Re: FCC ID: N7NAB300A Grantee: Sierra Wireless Inc.

This letter is in response to your request for additional information in you email of Thursday, March 23, 2000, Correspondence reference number 12966.

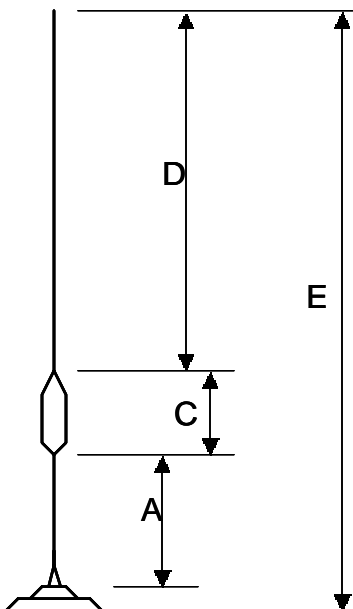
Re: question 1.

Dimensions of the antennas used are shown in the following chart in mm. A key to these dimensions are given in the accompanying diagram.

A lower element	C Coil length	D Upper element	E Overall height
Antenna #1	65	45	185	315
Antenna #2	100	80	210	400
Antenna #3	A+C=142		160	320
Antenna #4	65	50	225	365
Antenna #5	75	50	225	375

The designation “Antenna #1, #2 “ etc. correspond to the designations shown in sections 5.5 and 5.6 of the MPE test report.
